## Staff Report Memorandum November 16, 2023

To: Planning Commission  
From: Community Development Department  
Subject: Hale Centre Theatre Revised Beehive Academy Addition  
9886 S. Monroe St.  
(Civic Center, Community #2)

SPR10112023-006636  
CBD-O Zone  
0.55 Acres  
Bldg. Footprint 21,241  
Square Feet

(See November 16, 2023, proposed building elevation rendering below.)

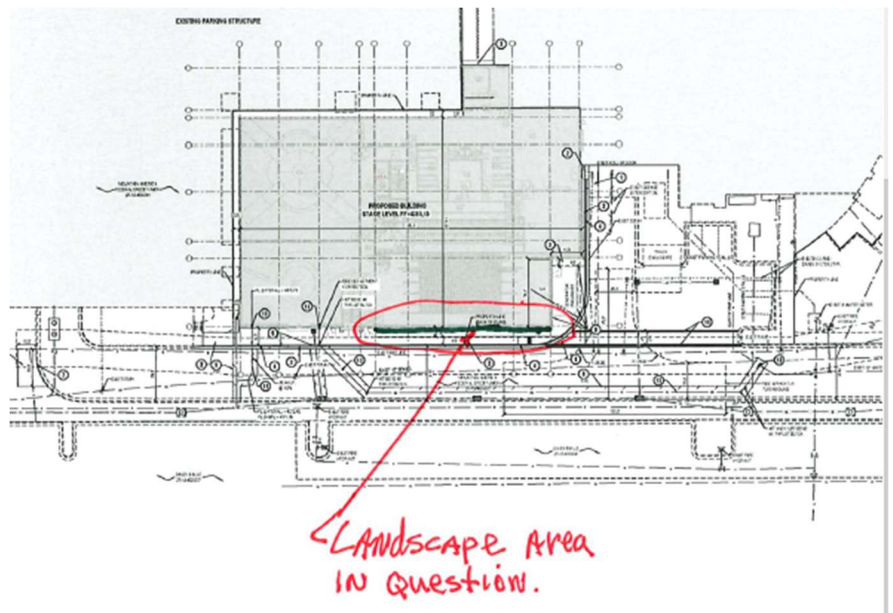
Staff is concerned about the portion of the existing parking garage structure that rises above the parapets, especially now that mansard roof parapets and towers features have been eliminated. During the ARC committee meeting held on March 30, 2023, there were discussions on applying various finishes to the concrete structural elements and CMU infill walls, such as adding more stucco/EIFS materials; applying a colored stucco topcoat material; painting that surface; or adding metal screening to match the west side of the parking structure. None of these possible mitigation measures were endorsed by the ARC Committee or the Planning Commission, and therefore, the prior plan was approved without anything being done to the unfinished parking garage wall exposure. **The Commission may want to revisit this issue now that the vertical exposure distance above the building parapet is approximately 19 feet instead of approximately 9 feet with the prior plan.**

The staff's second concern is the proposed lack of any foundational level landscaping along the south side of the new building. Foundational landscaping is required by the city Development Code (21-23-03-D (1) and the Architectural Design Standards (Section IV-D-6). The owners do not want to maintain any landscaping here, since they have no other landscaping responsibilities for the original Hale Centre Theatre building, as the Monroe Street frontage is a city owned and maintained public area/plaza. The owner has concerns about the cost of installing the necessary irrigation and metering required by the city for landscaping to be installed in this limited area. The Sandy City Development Code, Section 21-25-03 (D), General Building Locations and Setbacks, (1) States: No building shall be closer than 6 feet from any private road, driveway, or parking spaces in order to allow areas adjacent to the building for foundational landscaping and buffering of pedestrian walkways. Exceptions may be made for any portion of the building that contains a drive-up window or where the Planning Commission may approve a zero-foot setback.

Due to the fact that the Planning Commission can modify requirements of the Architectural Design Standards upon specific site plan reviews, and the provision of section 21-25-03-D (1) above, the Planning Commission has the latitude to determine that the foundational landscaping in this application is not needed and approve the zero-foot building setback from the pedestrian walkway.

The Planning Commission should consider these issues and weigh these concerns raised, and decide on the appropriate mitigation measure if any, that the Commission may want to include in the approval motion as additional conditions of approval. The Planning Commission is the decision maker on this as the designated "land use authority" and can waive or modify city requirements in this application.
